Access Compliance Report

Public Rights-of-Way

(Curb Ramps)

Intersection ID: 26345	Main Street: BEAUCATCHER_LN	Cross Street: RHETT_BUTLER_PL	Location: NE
ADA ID: 84AA886BC5AA	Ramp Type: Perp	Initial Pass/Fail: Fail	Overall Compliance: No
Severity Score: 42.5			
Codes/Mitigation Info/Possible Solution		Field Measurements/Component Compliance

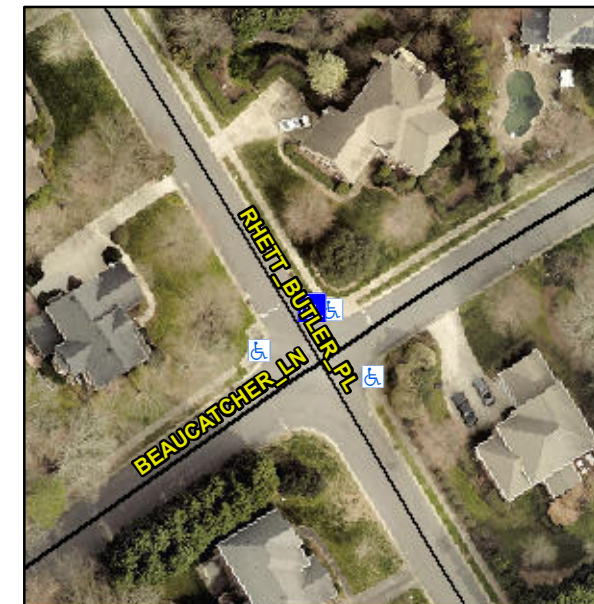
Not Found, R304.5.1, R304.5.3

Compliance	Description	Data	Compliance	Description	Data
N/A	Ramp Length (in)	48.0	Yes	Ramp Slope (%)	5.0
No	Ramp Width (in)	33.0	No	Ramp XSlope (%)	7.1
N/A	Flare Type LT	N/A	N/A	Flare Type RT	N/A
N/A	Flare Slope LT (%)	N/A	N/A	Flare Slope RT (%)	N/A
N/A	Flare Traversable LT?	N/A	N/A	Flare Traversable RT?	N/A
N/A	Landing Length (in)	N/A	N/A	DWS Provided?	N/A
N/A	Landing Width (in)	N/A	N/A	DWS Contrast?	N/A
N/A	Landing Slope (%)	N/A	N/A	DWS Length (in)	N/A
N/A	Landing X Slope (%)	N/A	N/A	DWS Full Width?	N/A
N/A	Landing Curb? (Y/N)	N/A	N/A	DWS Offset (in)	N/A
N/A	Shared Landing?	N/A			
N/A	Gutter Ponding?	N/A	N/A	Gutter Slope (%)	N/A
N/A	Gutter Lip Ht (in)	N/A	N/A	Gutter X Slope (%)	N/A
N/A	Painted X Walk1?	No	N/A	Painted X Walk2?	N/A
	X Walk 1 Direction	To W		X Walk 2 Direction	N/A
N/A	X Walk 1 Width (in)	N/A	N/A	X Walk 2 Width (in)	N/A
	X Walk 1 Slope (%)	5.0		X Walk 2 Slope (%)	N/A
	X Walk 1 X Slope (%)	3.6		X Walk 2 X Slope (%)	N/A

Remove & Replace Entire Ramp.
